ENGINE - FUEL AND CONTROL - REPROGRAM DATA ENTRY PLUG (DEP) FOR A BUMP RATING CHANGE -
CATEGORY CODE 5 - MOD.ENG-73-0033

V2500-ENG-73-0033

Modification of data entry plug assembly (Remove the sealing plugs, contacts and jumper pins for the engine serial numbers specified in Paragraph 2. A.)

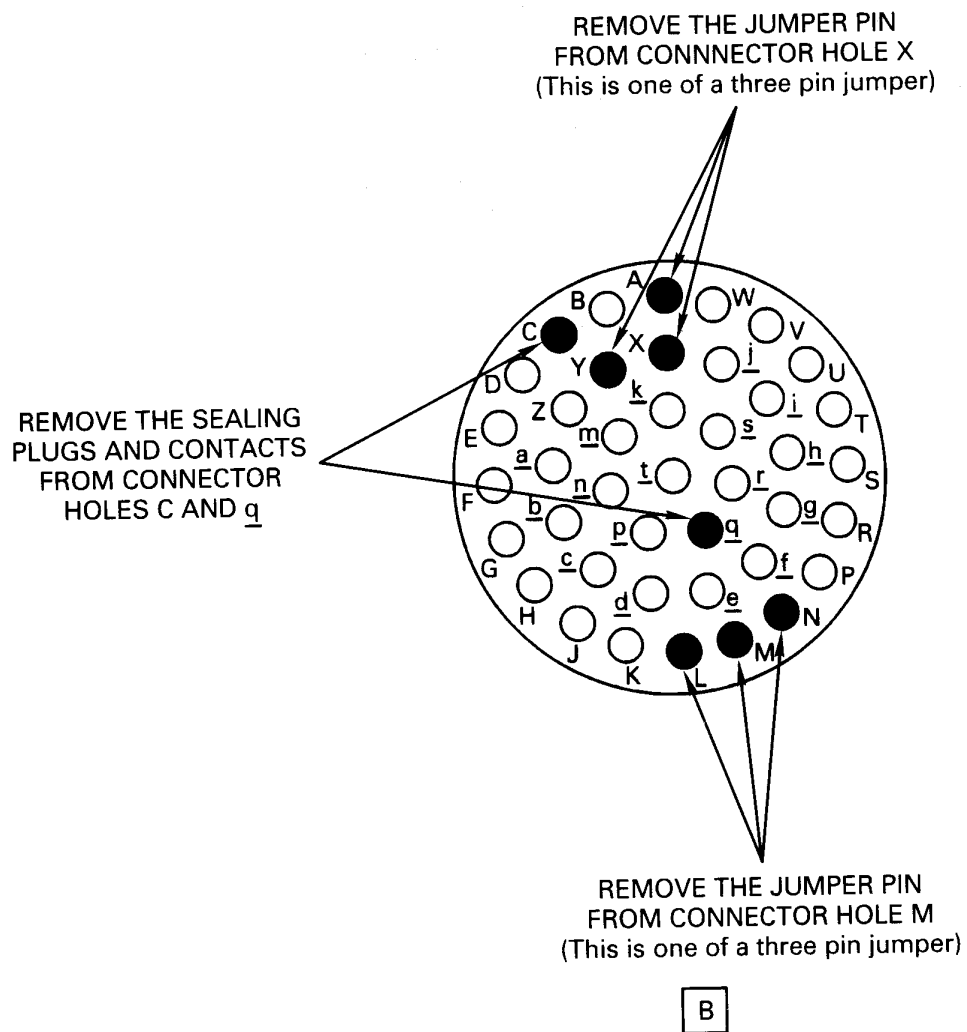
- 1 Remove the Sealing Plugs and Contacts from connector holes C and q.

- 2 Remove the Jumper Pin from connector hole X.

- 3 Remove the Jumper Pin from connector hole M.

Modification of data entry plug assembly (Install the sealing plugs, contacts and jumper pins for the engine serial numbers specified in Paragraph 2. A.)

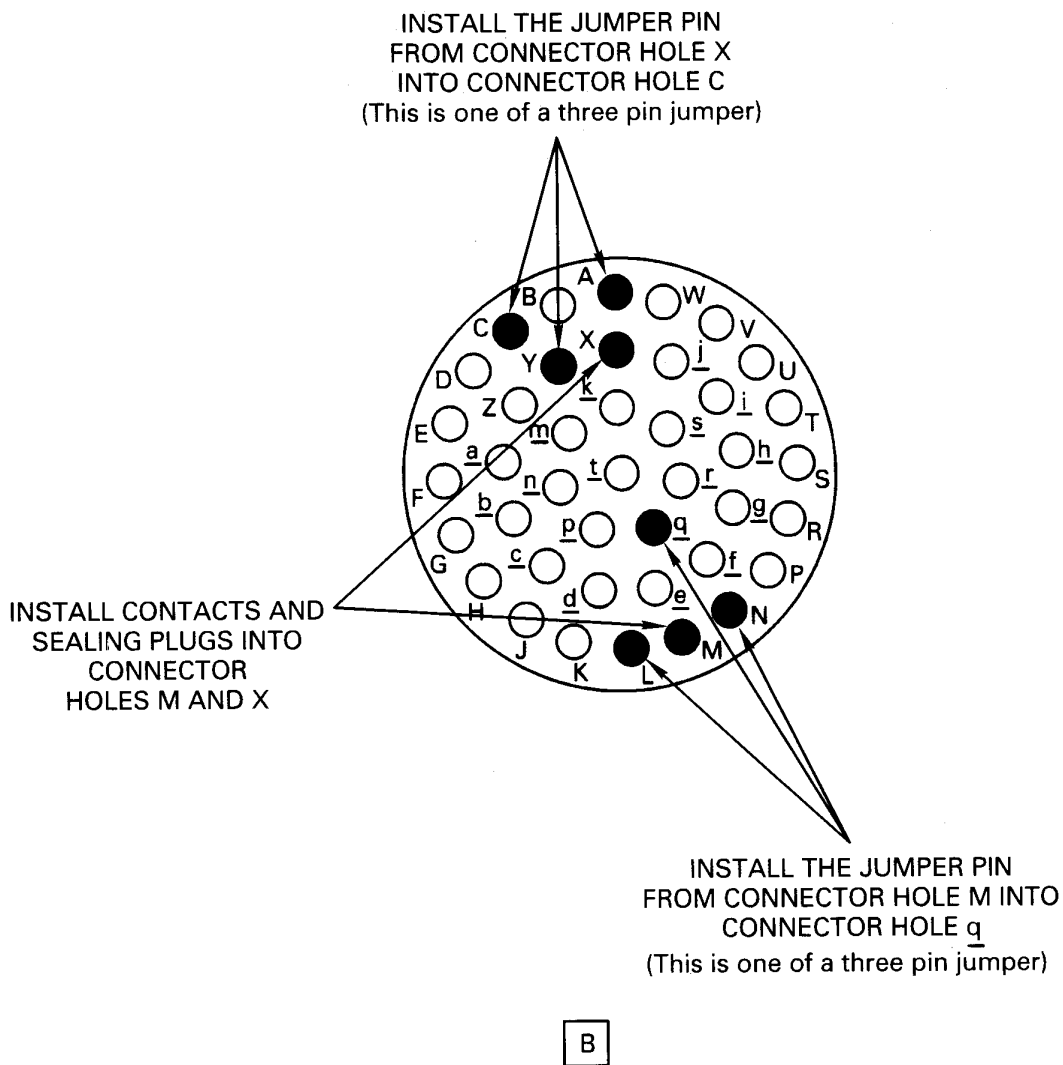
- 1 Install the Jumper Pin from connector hole X into connector hole C.

- 2 Install the Jumper Pin from connector hole M into connector hole q.

- 3 Install the Contacts and Sealing Plugs into connector holes X and M.

Modification of data entry plug assembly (Remove the sealing plugs, contacts and jumper pins for the engine serial numbers specified in Paragraph 2. C.)

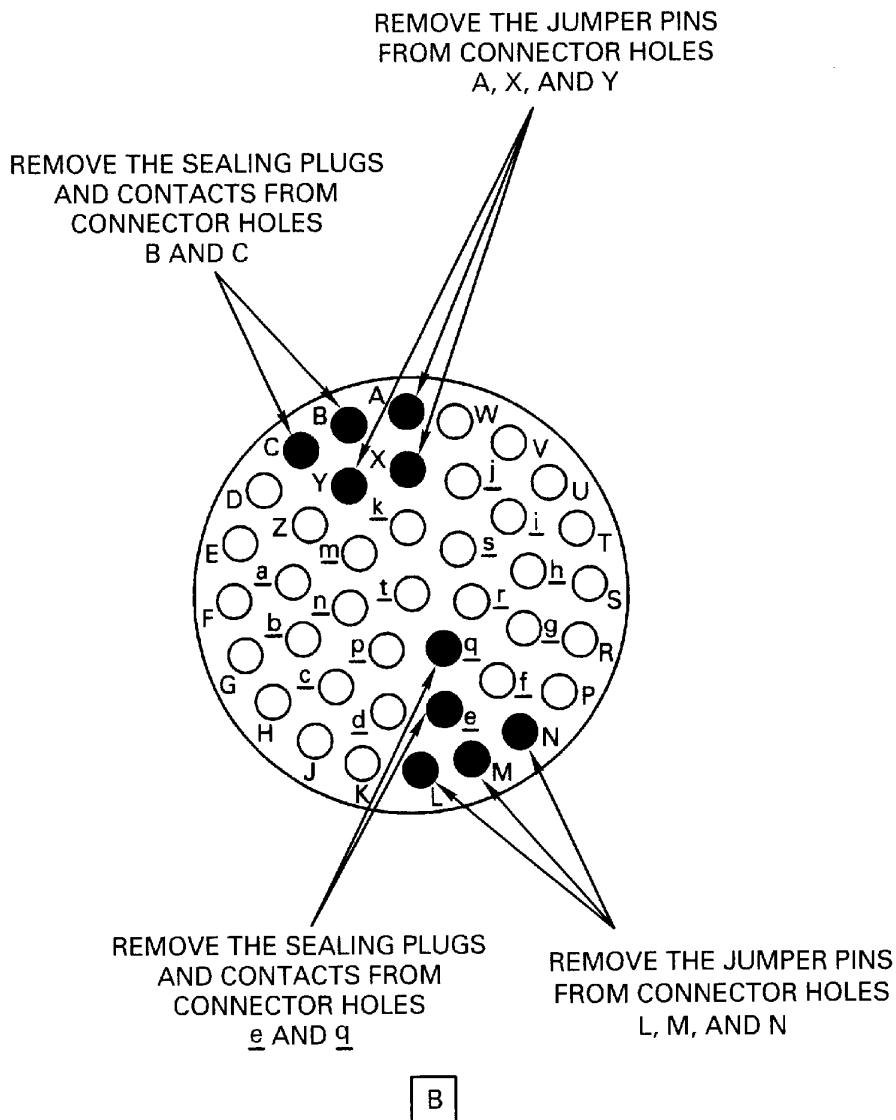
- 1 Remove the Sealing Plugs and Contacts from connector holes B, C, e and q. Discard the Sealing Plugs and Contacts.
 - 2 Remove the Jumper Pin from connector holes A, X, and Y. Discard the Jumper.

- 3 Remove the Jumper Pin from connector holes L, M and N. Discard the Jumper.
- (c) Install the Jumper Pins, as follows:
- Refer to Figure 1. Use the approved procedure in Reference (3), Chapter/Section 73-22-35, Repair-001 (VRS3500).

Modification of data entry plug assembly (Install the sealing plugs, contacts and jumper pins for the engine serial numbers specified in paragraph 2. C.)

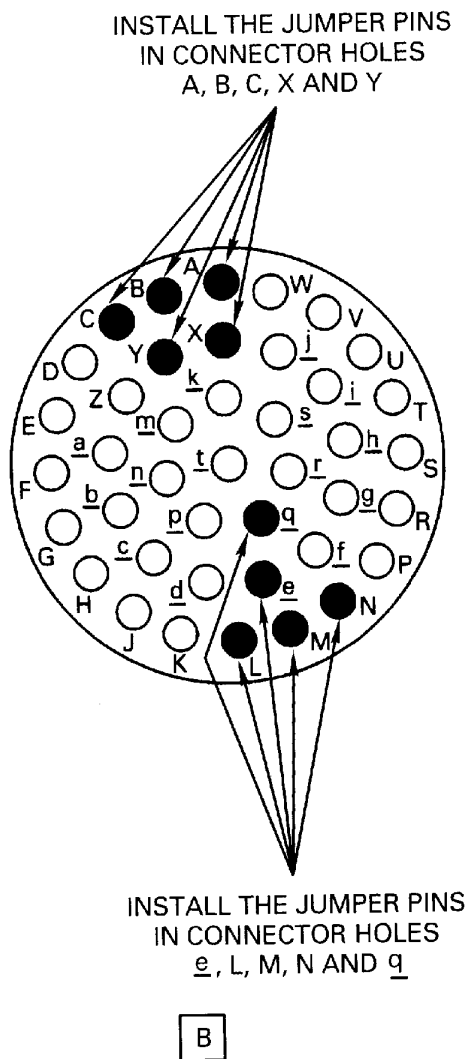
- 1 Install either the 5A9214 or the 2A2036 Jumper Pins into connector holes A, B, C, X and Y.
 - 2 Install either the 5A9214 or the 2A2036 Jumper Pins into connector holes e, L, M, N and q.

Modification of data entry plug assembly Remove the sealing plugs, contacts and jumper pins For Engines serial numbers specified in paragraph 2.D.)

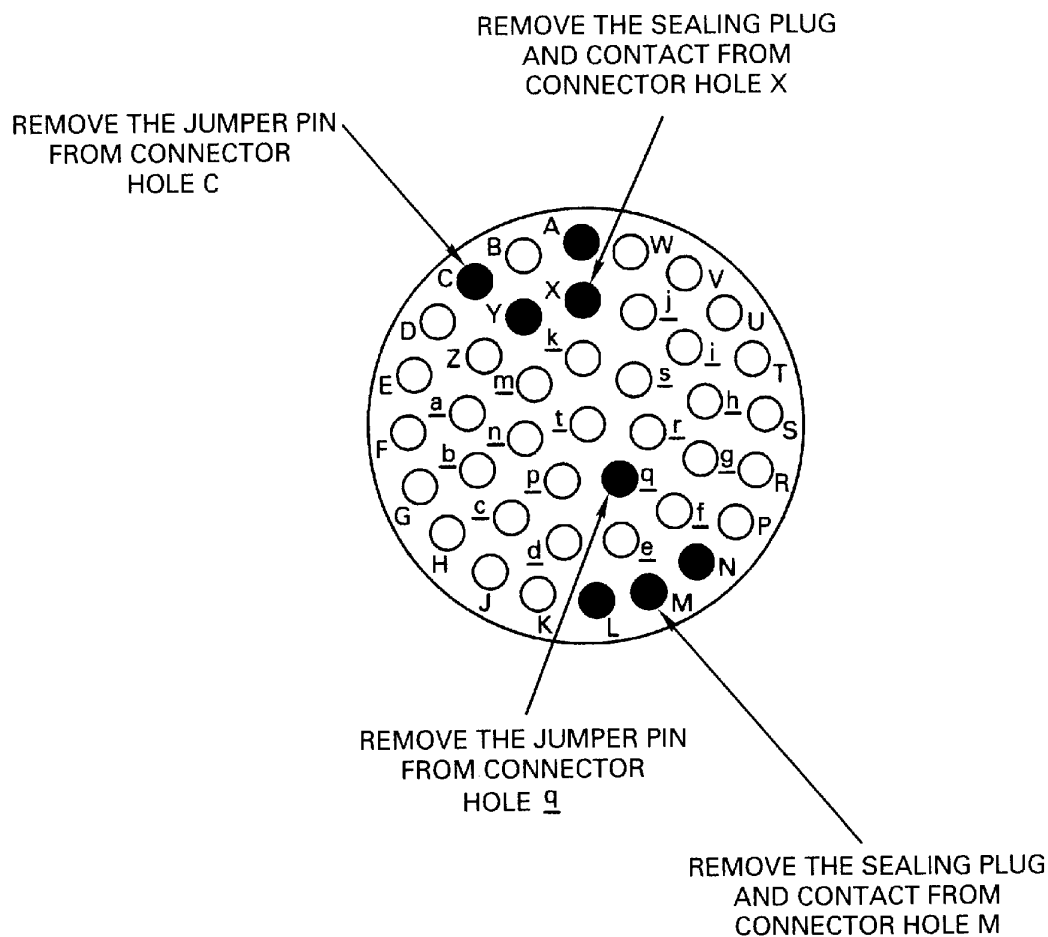
- 1 Remove the Sealing Plug and Contact from connector holes X and M. Save the Sealing Plugs and Contacts. These parts will be used again.

- 2 Remove the Jumper Pin from connector hole C.

- 3 Remove the Jumper Pin from connector hole q.

Modification of the data entry plug assembly (Install the jumper pins, contacts and sealing plugs For Engines serial numbers specified in Paragraph 2.D.)

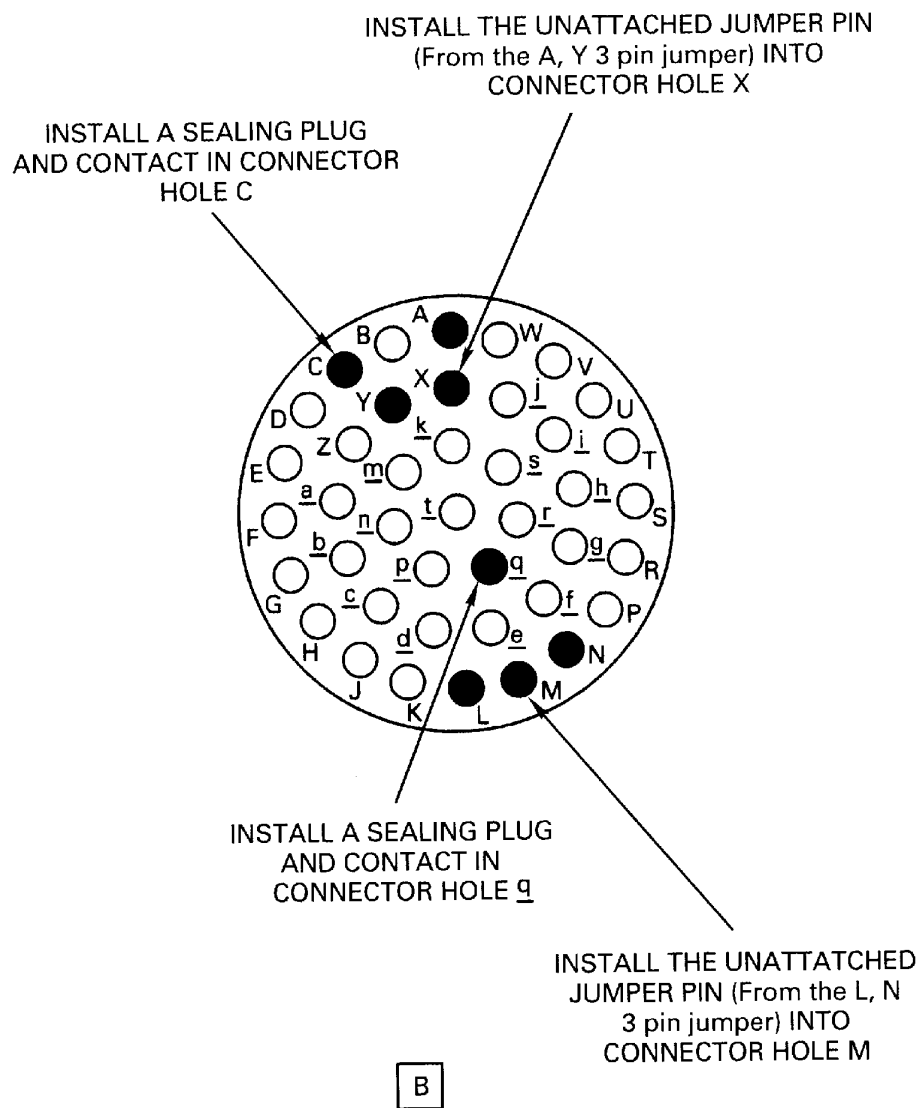
- 1 Install the Jumper Pin removed in step (b) 2 into connector hole X.

- 2 Install the Jumper Pin removed in step (b) 3 into connector hole M.

- (d) Install the Sealing Plugs and Contacts removed in step (b) 1 in connector holes c and q.

Identification of data entry plug rating number
Fig.2

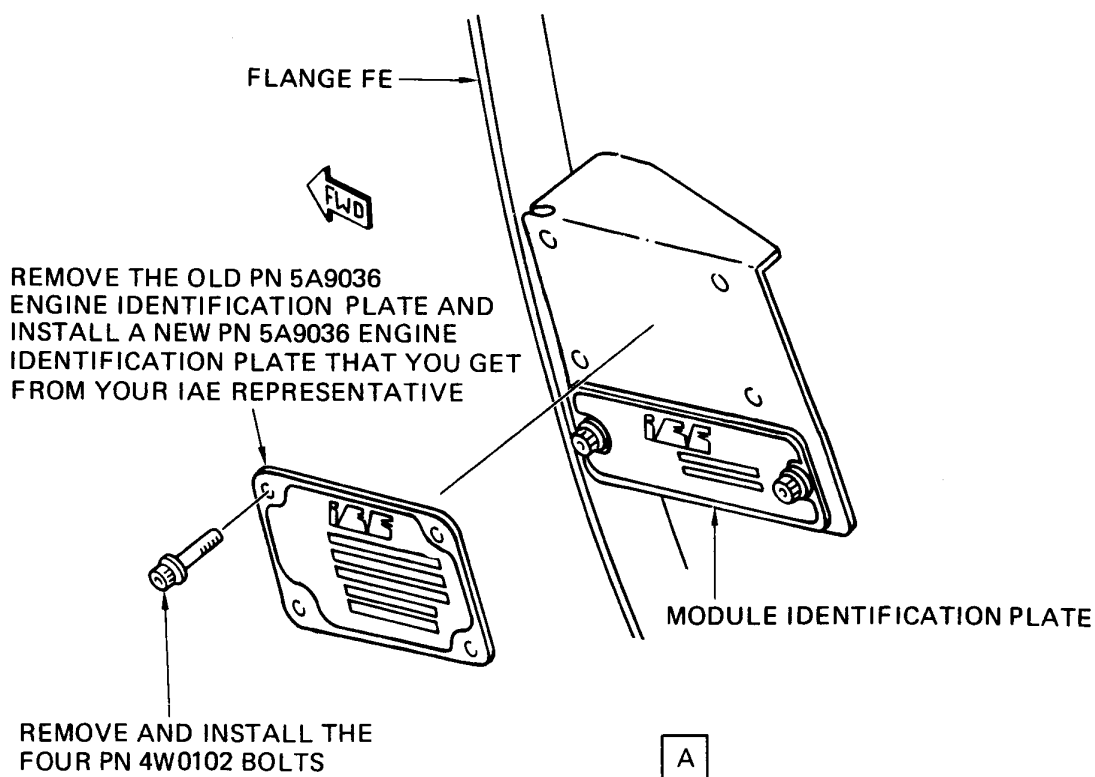
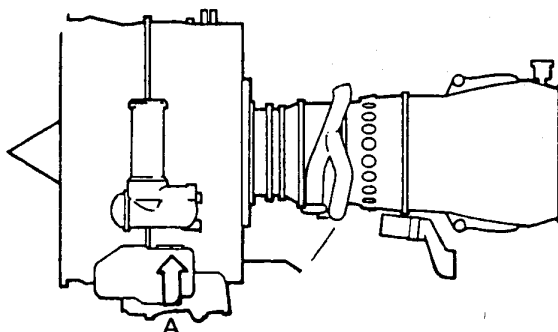
- 1 Mark out the RATING No. -00 from the Data Entry Plug Backshell. Use the vibration peen method.

- 2 Mark the new RATING No. -01 on the Data Entry Plug Backshell, adjacent to the old RATING No. Use the vibration peen method.

DEP ASSY 5A0432
S/N J1YA XXXX
RATING No. 1 ← IDENTIFY RATING No.
EPR MOD. No. XX TO ADD -00,-01 OR -03
ENG. S/NVXXXX

NOTE: WHEN THE NEW IDENTIFICATION MARK IS
MADE USE A MINIMUM AMOUNT OF SPACE.
IT IS POSSIBLE THAT MORE MARKS WILL
BE NECESSARY AT A DIFFERENT TIME.

Location of the engine identification plate
Fig.3

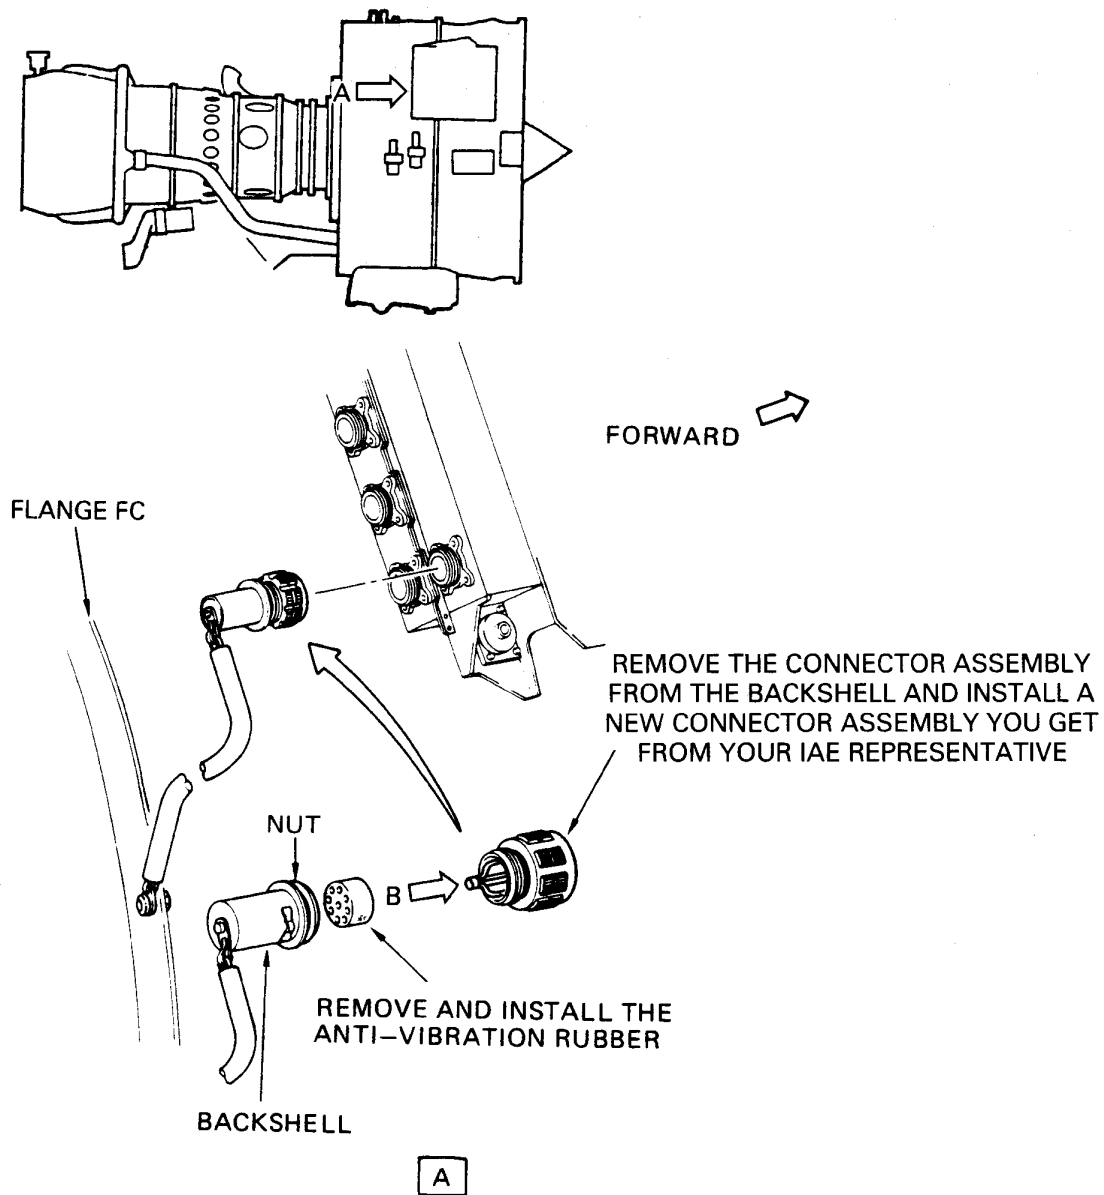
- (i) Remove the four bolts that hold the Engine Identification Plate to the bracket located on the fan case at the 9 o'clock position.

- (l) Install the new Engine Identification Plate to the bracket with the 4W0102 bolts (4 off).
